WHITE LAKE TOWNSHIP
INTER-OFFICE MEMORANDUM
COMMUNITY DEVELOPMENT DEPARTMENT

SUBJECT: **Edendale Crossing**
Final Site Plan Approval
Property described as parcel number 12-29-476-025, located at the northwest corner of Bogie Lake Road and Cedar Island Road, consisting of approximately 45.47 acres.

RE: Edendale Crossing
Final Site Plan Submission

Cedar Island & White Lake Middle School Sidewalk Plan
"EDENDALE CROSSING" SITE CONDOMINIUM
PART OF THE SOUTHEAST 1/4 OF SECTION 29, T3N, R8E
WHITE LAKE TOWNSHIP, OAKLAND COUNTY, MICHIGAN

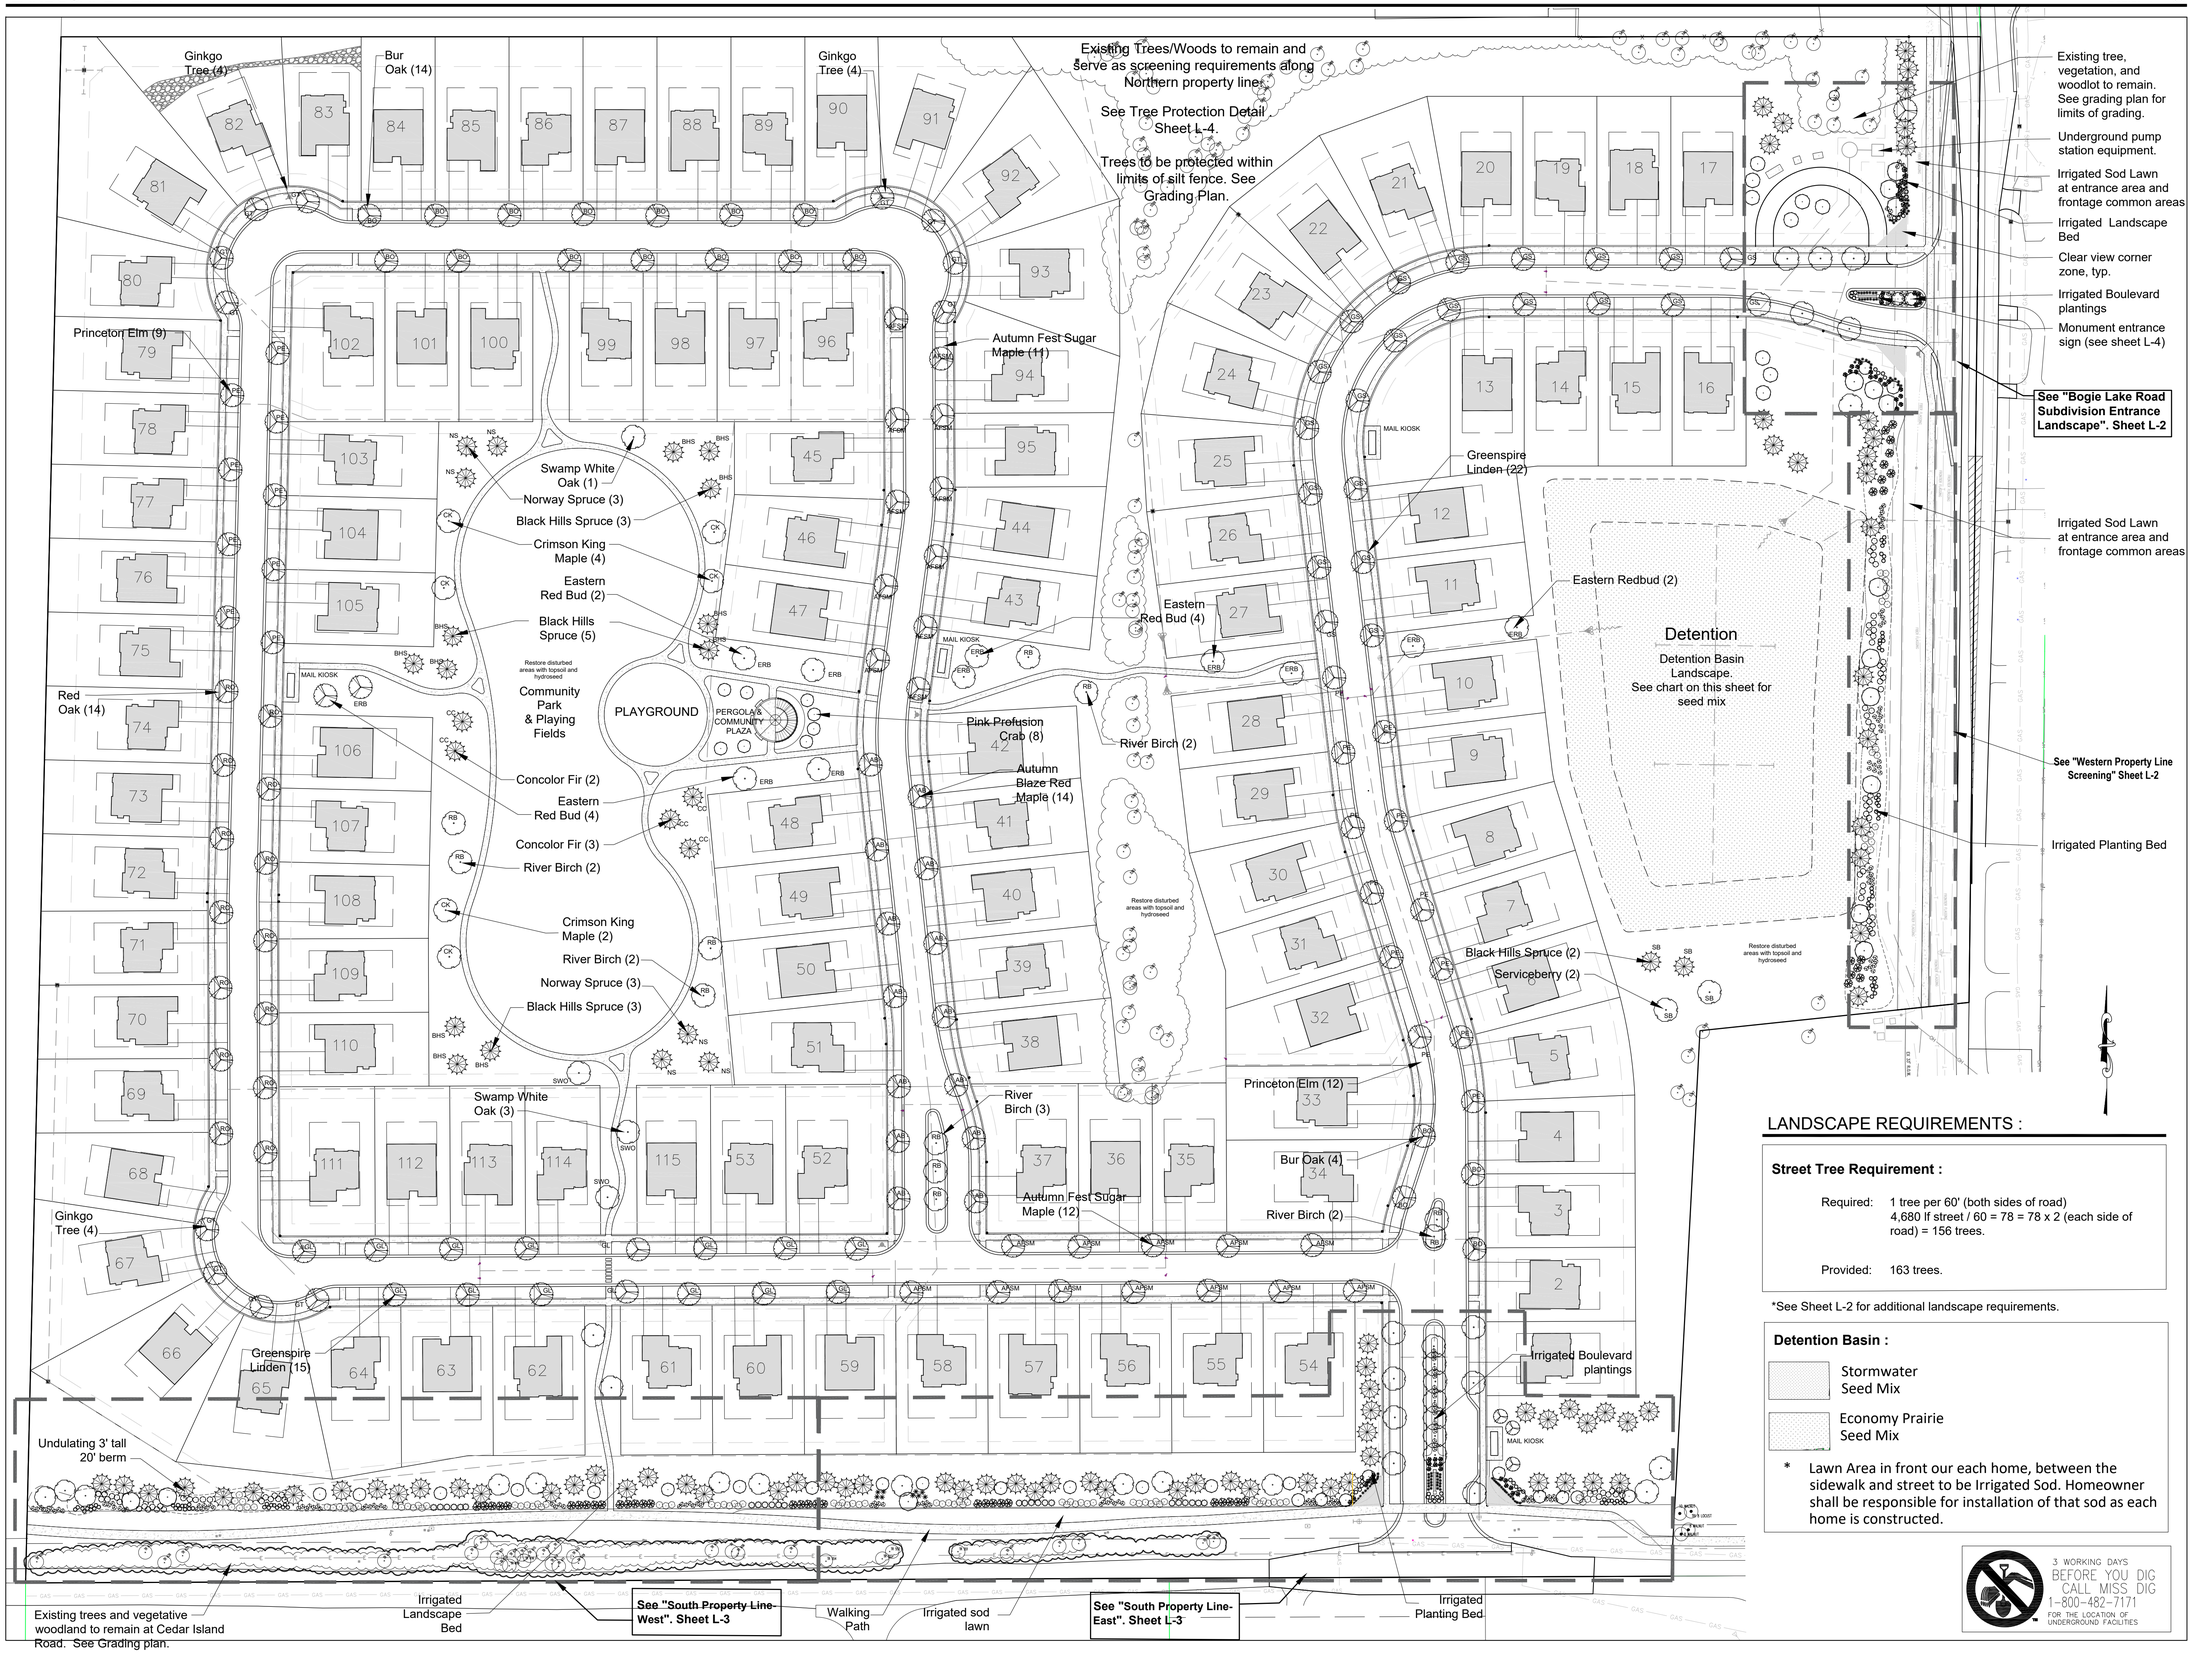
1. *Sheet 19-Cedar Island & White Lake Middle School Sidewalk Plan- Remove 'Proposed Pedestrian School Crossing' note to the west of Carla Hills Drive as this was where the safety path was previously proposed.* **Comment outstanding.**
2. *Sheet 3- The number of lots for each phase has not been updated to correspond with the reduction in total units from 125 to 120. Please update.* **Comment addressed. Quantities have been updated.**

Comment is now outstanding due to the following requested clarification and change in sidewalk layout: The proposed 8' wide path along Cedar Island Road has now been shifted in its entirety to the north side of the road. The Existing Conditions Plan- Overall (Sheet 2) shows 43' existing ROW along Cedar Island Road in front of Parcel 12-29-476-007 while the Overall Site Plan and Notes (Sheet 3) shows the existing ROW in this area as 33'. Please clarify. The right of way along Parcel -007 will determine whether a sidewalk easement will need to be granted by this property owner. Additionally, please revise '8' Wide Safety Path Connection to Huron Valley School Parking Lot' reference notes on Sheets 3 and 5 from Sheet 17 to Sheet 19. Comment addressed. ROW width has now been corrected to 43' on the 'Overall Site Plan & Notes' (Sheet 3), so it now appears that an easement for the proposed path would not be required from Parcel -007. In addition, sheet references have been updated. **Comment remains as a notation.**

Sheet: L-2

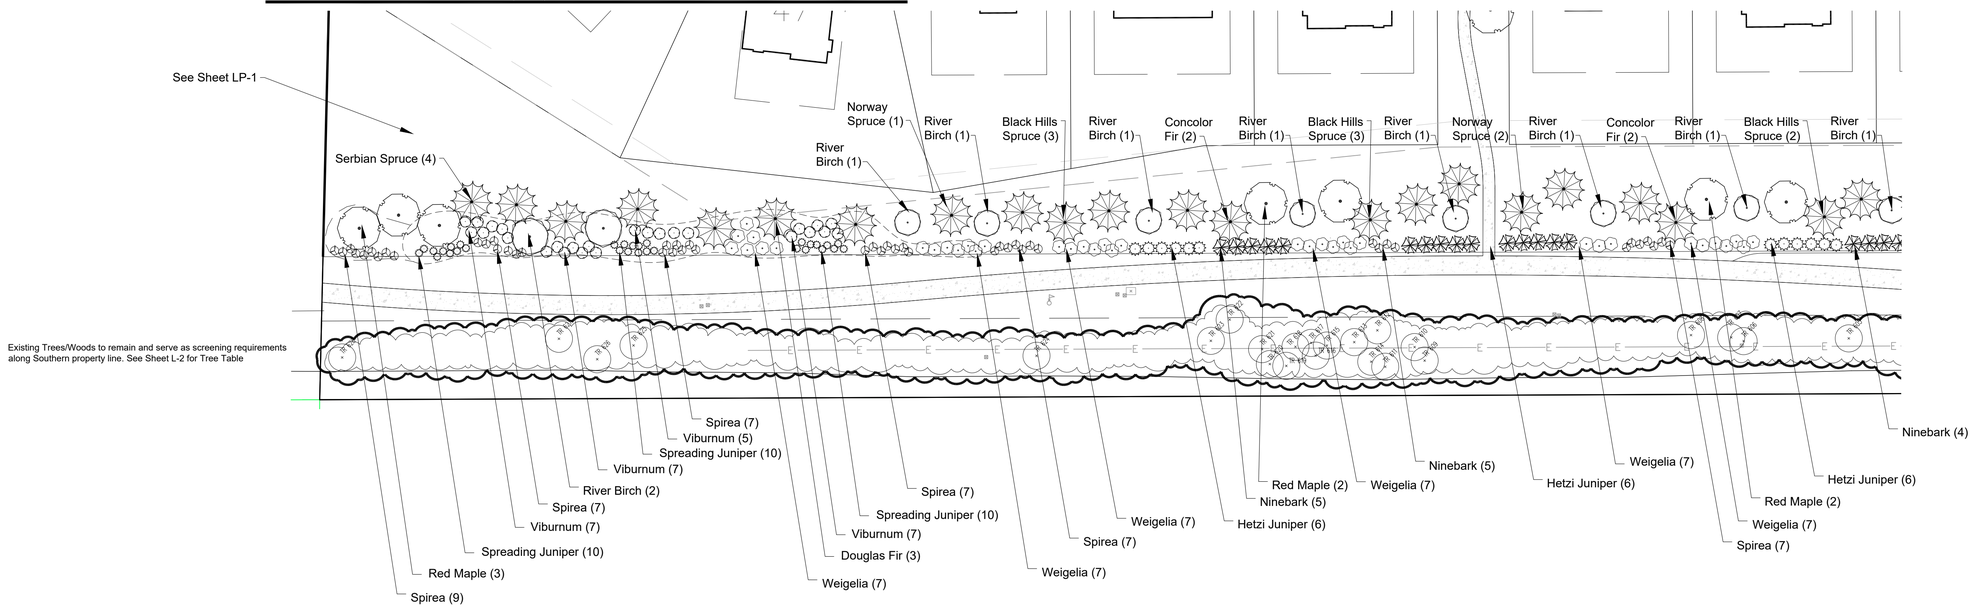
CWA Comment: *Sheet L-2 has a table stating 474 6" dbh trees or greater are located on the site. 128 of those trees are to remain on site.*
